Edinburgh Park Arena: Planning application 24/00820/FUL

DRAFT Response from Spokes Planning Group, March 2024

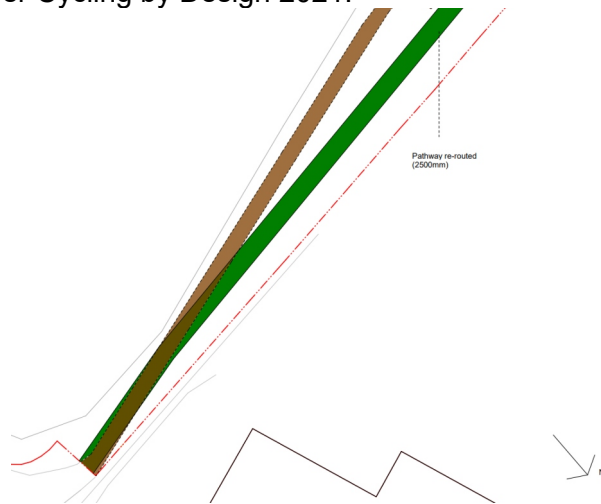
The proposed site is bounded on 3 sides by the existing Quiet Route 8 which links the Roseburn (for the City Centre) to Edinburgh Park via mainly segregated cycleways / paths. This is a primary and high quality link that Spokes would like to see improved. Given the amount of housing due to be built at Edinburgh Park it is very important the capacity is adequate for this especially given the Council's own modal share targets.

The proposals appear to do nothing to improve the adjacent path under the railway apart from cutting back vegetation. Spokes is concerned that during event start and end it will be impossible for cycle users to use the underpass safely.

There seems to be a reliance on core paths and a lack of knowledge on the Quiet Routes network in the Transport Assessment. The proposed realignment of the path to the north of the Arena site is shown at an unacceptable 2.5m width. This should be 4m wide at minimum per Cycling by Design 2021.

The diagrams in the Transport Statement provide no reassurance that the realigned path connects to any meaningful routes further westwards. So as such we find it difficult to support this part of the proposal.
